UNITED STATES PATENT AND TRADEMARK OFFICE

APPLICATION NO.	FILING DATE	FIRST NAMED INVENTOR	ATTORNEY DOCKET NO.	CONFIRMATION NO.
10/679,103	10/04/2003	David J. Danitz	PAT-1337-CIPCON	2233

Office Action Summary

DETAILED ACTION

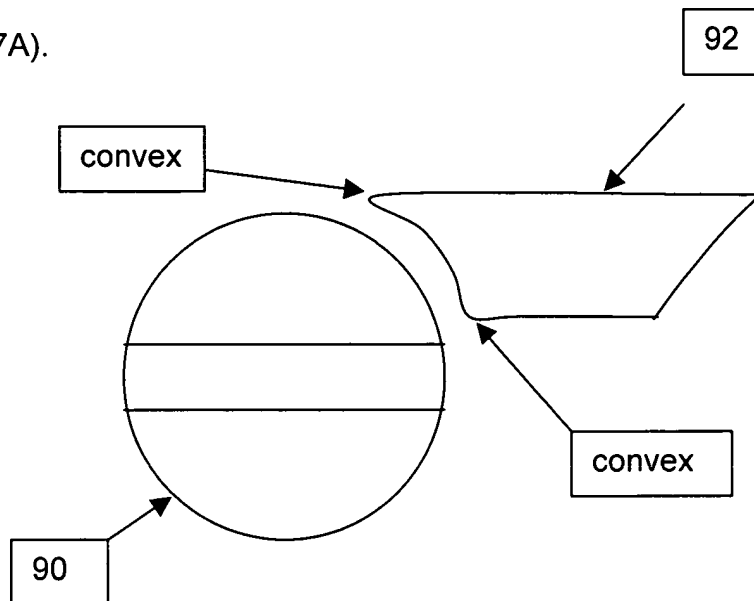
1. With respect to arguments regarding “a concave surface on the links 92 in Fig. 7A of Spence contacts the surface of the links 90. In contrast, as best shown in Fig. 3A of the present application, a convex surface of the beads 36b contacts the surface of an adjacent bead 36a”. Examiner respectfully traverses the applicant’s remarks: Spence discloses in Fig. 7A the contact surface on bead 92 or second bead includes concave surface and two convex surfaces in each of the three dimensions, x, y, and z (see picture below shows a partial enlargement view of Fig. 7A).
